UNITED STATES PATENT AND TRADEMARK OFFICE

APPLICATION NO.	FILING DATE	FIRST NAMED INVENTOR	ATTORNEY DOCKET NO.	CONFIRMATION NO.
10/551,624	06/26/2006	Stephane Moreau	17102/023001	5504

Office Action Summary	Application No. 10/551,624	Applicant(s) MOREAU ET AL.	
	Examiner ALEXANDER B. COMLEY	Art Unit 3746

DETAILED ACTION

FIG. 3

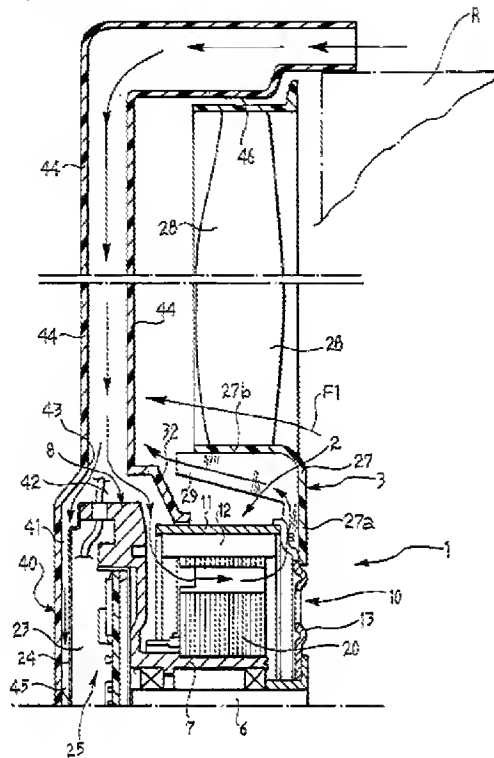
In regards to Independent **Claim 1**, and with particular reference to Figure 3 shown immediately above, Avidano discloses:

(1) A ventilation device (1) comprising a fan (3) capable of being driven rotationally by an open electric motor (2) which is firmly attached to a support (40, 44) intended for fixing said ventilation device, the fan consisting of a plurality of blades (28) which are distributed regularly around a bowl (27) inside which there are arranged internal ribs (29) capable of ventilating said open electric motor, characterized in that the support comprises a central part (32) which is connected in a substantially sealed manner to at least one peripheral portion (11) of the open electric motor.

As shown in Figure 3 above, Avidano et al. discloses an electric motor-driven fan unit for use in motor vehicles. Avidano's fan is designed with a hub and airflow structure that allows the fan's internal blades to cool the motor. In particular, Avidano states "A motor-driven fan includes an electric motor including a rotor and a stator in which the rotor includes an essentially cup-shaped cap which extends at least partly around the stator and has a plurality of lateral exit openings adjacent the bottom wall, and an impeller or fan including a hollow hub from which extends a plurality of main outer fan blades. This hub has a front wall fixed to the back wall of the cap of the rotor and a lateral skirt which surrounds the lateral wall of the cap in a radially spaced relationship. The hub is further provided with inner ventilation blades acting in operation to generate a cooling air stream which passes through the motor." (Abstract) Moreover, Avidano specifically describes the hub structure of Applicant's claimed invention by stating "The fan or rotor 3 of the motor-driven fan comprises a hollow hub 27 (FIG. 1) from which extends a plurality of main outer fan blades 28. The hub 27 has a front wall 27a fixed to the radial projections 15 of the disc element 13 of the cap 10, by means of rivets 29 or the like (FIG. 1). The hub 27 of the fan 3 further has a lateral, essentially cylindrical, skirt 27b which surrounds the side wall or ring 11 of the cap 10 in a radially spaced relation thereto. As is seen in FIG. 1, the hub 27 of the fan 3 is further provided, in the space 30 defined between the ring 11 of the cap 10 and the skirt 27b of the hub of the fan with internal fan blades 29 which extend in respective inclined planes with respect to the radial direction." (Column 2, Lines 36-48) Avidano discloses a main

support body (40, 44) that is composed of rear body 40 and aspiration duct 44. These two structures make up a rear-end support that helps to support the motor 2 within central support 32. As shown in Figure 3, central support 32 is substantially sealed to the outer periphery 11 of the motor 2, thereby helping to seal the motor within the support. In particular, Avidano states "In the embodiment of FIG. 3 a rear body 40 is fixed to the stator body 8 on the side opposite the fan 3, which extends in facing and spaced relationship with respect to the cover 24 and which surrounds the periphery of the stator body 8 lying close the annular separator element 32." (Column 3, Lines 42-45) Avidano goes on to disclose a physical connection between the element 32 and the motor stator by stating, "Conveniently, although not necessarily, the motor-driven fan 1 further includes a separator ring 32 (FIG. 1) of essentially conical form, disposed around the end of the cylindrical wall 11 of the cap 10 facing the stator body 8 as well as around the ends of the cooling fins 26 of this stator body facing the fan. The separator ring 32 the function of which will be described hereinafter, can be fixed to the stator body 8 in various known ways." (Col. 2, Lines 54-61) And finally, Avidano describes a substantial sealing function provided by the element 32 in stating "This air stream discharges out by passing between the rear edge of the skirt 27b of the hub 27 of the fan and the annular separator element 32. This latter acts to impede mixing of the air stream entering the electric motor 4 with the air stream leaving it, as well as impeding the ingress of extraneous bodies or atmospheric agents into the electric motor." (Col. 3, Lines 17-24) Clearly from this disclosure, support 32 is substantially sealed to the motor since it acts to precisely control the airflow paths to prevent mixing thereof, as

6. In regards to dependent **Claims 2-5 & 15**, the annular separator element 32 surrounds and holds the outer periphery of the motor element 2. Moreover, it can be seen in Figure 3 that the inner edge of separator element 32 cooperates with the annular wall of the motor in a continuous, contiguous fashion, while the cover 24 cooperates with the rear portion of the motor. In particular, Avidano states "The portion of the rear body 40 facing the cover 24 of the stator is conveniently provided with at least one projection 45 in contact with this cover for the purpose of reducing or cancelling the effects of vibration." (Column 3, Lines 52-55) In regards to dependent **Claims 6-10**, it can be seen in Figure 3 that a blind hole, which surrounds and holds the rear portion of the electric motor, is formed between the annular separator element 32 and the cover 24. This opening (or hole) is attached to the rear part of the motor by tight fitting, and forms a plate around the rear portion of the motor. Regarding dependent **Claims 11-14**, the annular separator element 32 forms a surface opposite the bottom of the hub (i.e. bowl) that directs airflow from the inside of the hub to the outside of the hub (See Figure 3). Moreover, the separator has a concave shape (a quarter of a circle) that is flat, extends discontinuously (as its contour changes), and extends substantially linearly at a portion thereof. Finally, in regards to dependent **Claims 16-18**, Avidano's fan contains a peripheral part 44 that forms a frame with the central part. Moreover, Avidano's fan is for use in both an engine cooling device, as

8. In regards to Applicant's argument that central element 32 is not a central part of support 40, the Examiner must respectfully disagree. As shown in Figure 3 above, the entire support structure is composed of rear body 40, aspiration duct 44, and central ring 32. These structures are formed as a single, integral piece, which is indicated by the crosshatching in the figure. With reference to Figure 4, Avidano shows that rear body 40 is fixed (i.e. supports) the stator body 8, which is a primary structure of the motor 2. Avidano discloses this supporting function of the body 40 by stating "In the embodiment of FIG. 3 a rear body 40 is fixed to the stator body 8 on the side opposite the fan 3, which extends in facing and spaced relationship with respect to the cover 24

9. In regards to Applicant’s argument that the ring 32 is not substantially sealed to the motor, the Examiner must respectfully disagree. As stated above, central support 32 is substantially sealed to the outer periphery 11 of the motor 2, thereby helping to seal the motor within the support. Avidano discloses a physical connection between the element 32 and the motor stator by stating, “Conveniently, although not necessarily, the motor-driven fan 1 further includes a separator ring 32 (FIG. 1) of essentially conical form, disposed around the end of the cylindrical wall 11 of the cap 10 facing the stator body 8 as well as around the ends of the cooling fins 26 of this stator body facing the fan. The separator ring 32 the function of which will be described hereinafter, can be fixed to the stator body 8 in various known ways.” (Col. 2, Lines 54-61) Most importantly, however, is Avidano’s disclosure describing a substantial sealing function
